Würth Elektronik eiSos GmbH & Co. KG EMC & Inductive Solutions

Product / Process Change Notification (PCN)			
PCN #:	PCN_FeSTAR-RING_20200501	Change Category:	
Affected Series:	WE-STAR-RING; 742715x; 742715xS	 □ Equipment / Location ☑ General Data □ Material □ Process □ Product Design □ Shipping / Packaging □ Supplier □ Software 	
PCN Date:	January 31, 2020		
Effective Date:	May 01, 2020		
Contact:	Product Management	Data Sheet Change:	
Phone:	+49 (0) 7942 - 945 5001	⊠ Yes	□ No
Fax:	+49 (0) 7942 - 945 5179	Attachment:	
E-Mail:	pcn.eisos@we-online.com	□ Yes	⊠ No
DESCRIPTION AND PURPOSE OF CHANGE:			
As a datasheet information amendment and correction, Würth Elektronik will change the tolerance type from "typ." to "±" tolerances and the General Tolerances Standard for not specified Dimensions.			
Additional one dimension in the datasheet of part numbers 7427151 and 7427151S will be corrected.			
This is a Datasheet correction and amendment only. There will be no change in form, fit, function, quality or reliability of the product.

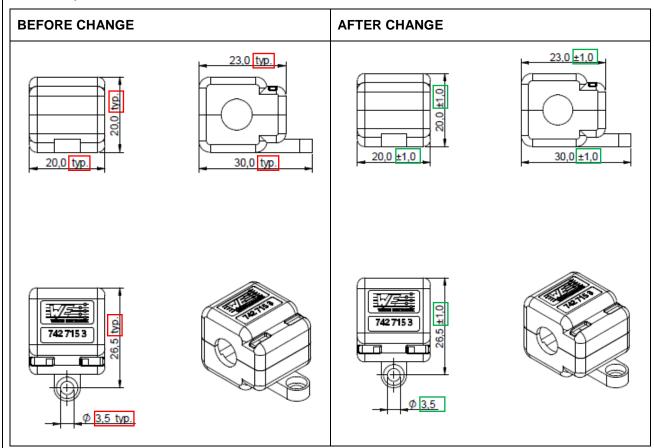
1. Change: Tolerance type from "typ." to "±"

Validity: 742715x; 742715xS

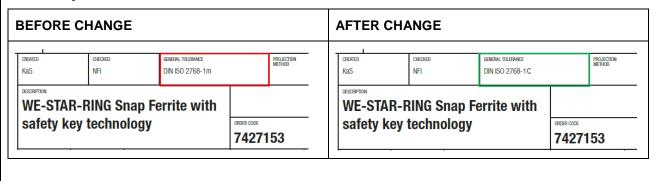
2. Change: General Tolerance Standard from DIN ISO 2768-1m to DIN ISO 2768-1c

Validity: 742715x; 742715xS
